**GLOBAL NUCLEAR FUELS – AMERICAS  
REQUEST FOR SUPPLEMENTAL INFORMATION**

**Figure 3-1 Inelastic Behavior of Frames with Hinges in Beam Span**

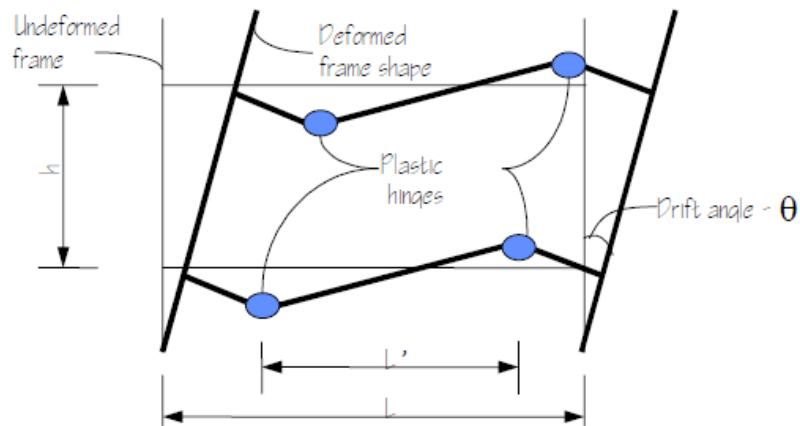
As discussed in Figure 3-1 of FEMA 350<sup>1</sup> provided below, the conditions required for ensuring adequate ductile behavior of frame structures rely on the development of sufficient number of plastic hinges forming in the beams and providing significant energy dissipation. Also, as discussed in the figure, development of plastic hinges in the column is undesirable as this provides relatively little energy dissipation. Although the staff understand that there is a certain level of ductility in the FMO/FMOX structure, the existing report provides little evidence to support the use of a response modification factor consistent with an Intermediate Moment Frame structure.
